FINAL ENVIRONMENTAL IMPACT REPORT

FIRE STATION NO. 9 AT 4101 LONG BEACH BOULEVARD

CITY OF LONG BEACH

SCH #2022020416

FIGURE 2.1

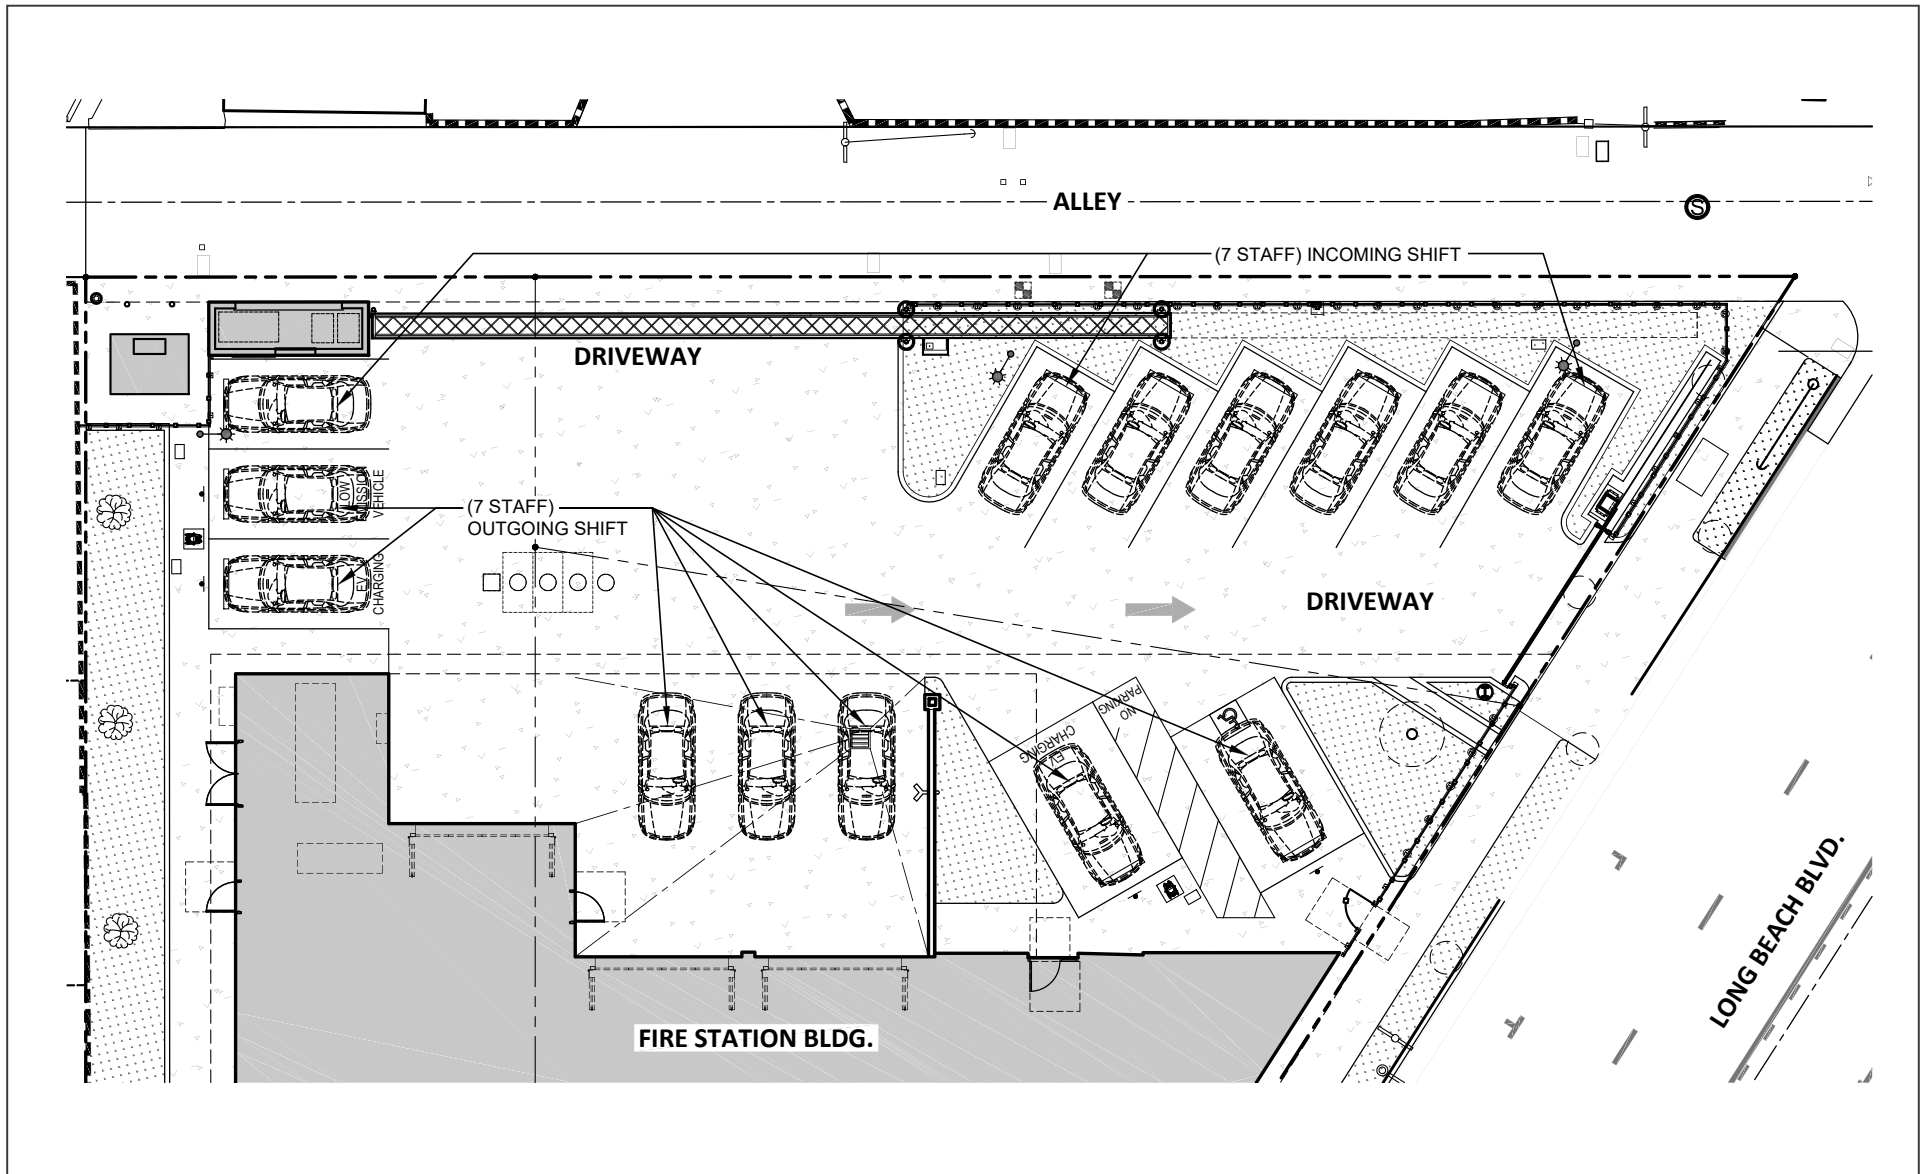
| 1. Firefighter parking will be at the station and not street parking as the streets are already impacted. Please discuss how the shift change will assure this happens. | P-1-1 |

CEQA does not consider the adequacy of a project's parking or its impacts on parking unless it will result in significant secondary effects on the physical environment. Fire Department shift changes would typically take place between 6:30 a.m. and 7:30 a.m., with a goal for all personnel to arrive at 7:00 a.m. As shown in the Final EIR, Figure 2.1, below, Shift Change, all personnel vehicles will park on site and a “shuffling” of vehicles will occur at the change of shift, to allow the on-coming shift to park. There are a total of 11 parking spaces with 7 staff on per shift. Three vehicles belonging to the outgoing shift will be staged to exit allowing the on-coming crews to park. Therefore, there is no need for curbside parking by fire personnel during the shift change. This comment does not address the environmental analysis or conclusions of the Draft EIR. Therefore, no further response is necessary.
